METROPOLITAN GOVERNMENT OF NASHVILLE AND DAVIDSON COUNTY

STAFF RECOMMENDATION 1429 Roberts Avenue February 17, 2016

Application: Partial demolition; New construction - addition
District: Eastwood Neighborhood Conservation Zoning Overlay
Council District: 06
Map and Parcel Number: 08302007500
Applicant: Steve DeSoto
Project Lead: Sean Alexander, sean.alexander@nashville.gov

✚ floor plan

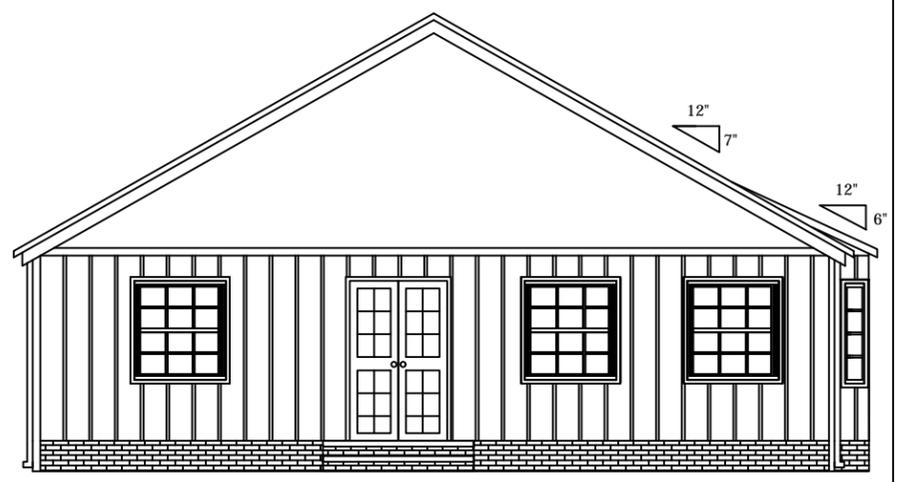
Orientation: The orientation of the building will not change, with the primary elevation facing the street directly. The existing right-side gravel driveway will be removed, which is appropriate, and Staff recommends that a new walkway be added to connect the front porch to the street in order to meet section II.B.1.f of the design guidelines.

Appurtenances & Utilities: No change to the HVAC and other utilities is indicated. Staff asks that the HVAC be located on the rear façade, or on a side façade beyond the midpoint of the house. Staff finds that the project will meet section II.B.1.i of the design guidelines.

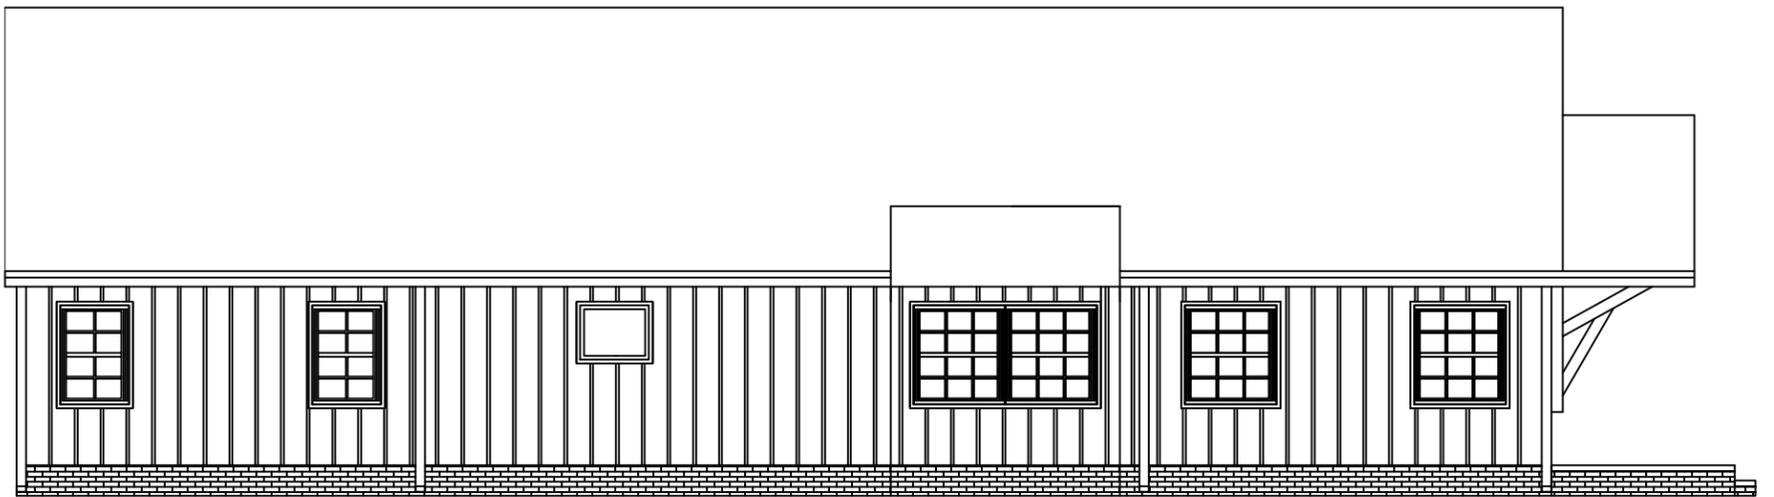
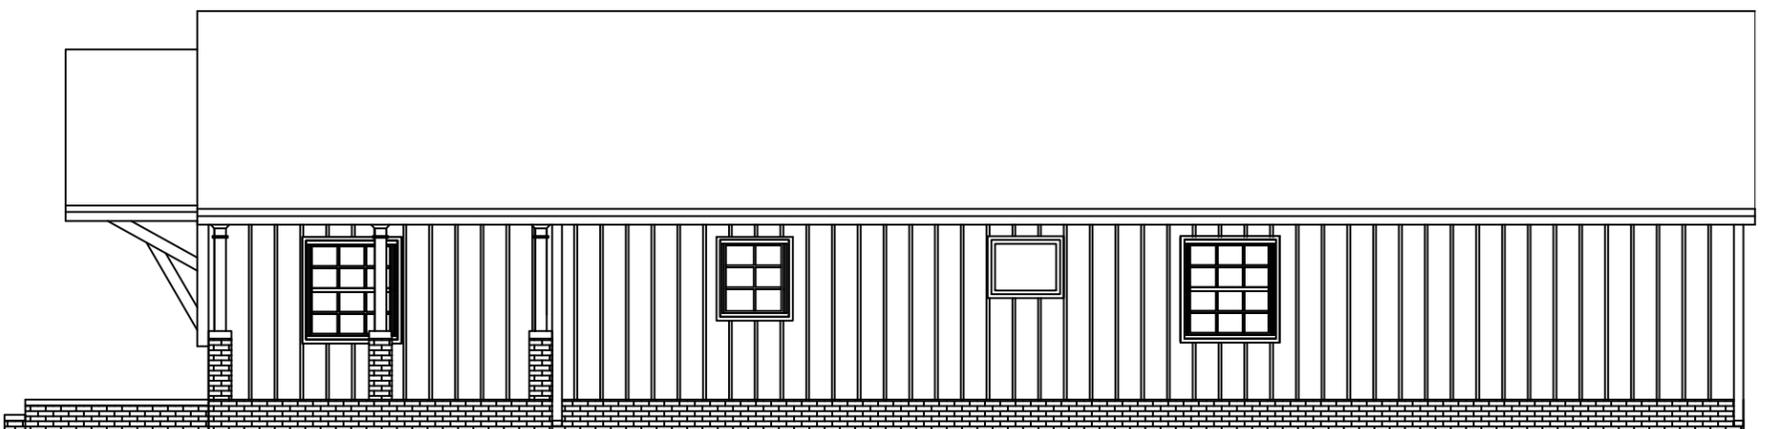
Materials: The walls of the existing building and the addition will primarily be clad in smooth-faced cement-fiber board-and-batten siding with cement-fiber trim. This type of siding is typically seen on outbuildings or as a secondary material but not the primary material of principle buildings. Staff recommends board-and-batten may be used in the newly created gable field with traditional clapboard or panel siding below with a trim board between. The trim will be cement-fiberboard. The roof will be gray architectural fiberglass shingles. The foundation will have a brick or stone foundation. Staff asks to approve masonry materials prior to purchase. The stone shown appears to have a horizontal dry-stack design, which is not appropriate for this neighborhood. Staff recommends a mortared square/rectangular stone for both the foundation and the porch pedestals. Staff recommends final approval of all masonry samples by staff prior to purchase and installation. The windows will be wood double-hung windows and the doors will also be wood. The specific window and door selections are indicated on the submitted elevations, and have been approved previously. With a traditional siding on the first story and the masonry to be approved prior to purchase and selection, Staff finds that the project will meet section II.B.1.d of the design guidelines.

Proportion and Rhythm of Openings: The windows on the front of the building will be generally twice as tall as they are wide, consistent with the historic proportions of openings. The windows on the side elevations are depicted as being square. Staff recommends that these be more vertically oriented. There are no large expanses of wall space without a window or door opening. With the condition that the windows on the side elevations are vertically oriented, Staff finds the project's proportion and rhythm of openings to meet Section II.B.1.g.

- Board-and-batten may be used as a secondary material, but the primary cladding is clapboard or other siding material typical of the area;
- Masonry is approved by Staff prior to purchase and installation;
- A walkway is added to connect the front porch to the street;
- The windows on the side elevations be vertically oriented as they are on the front; and
- The HVAC be located on the rear or the side elevation behind the mid-point of the building.
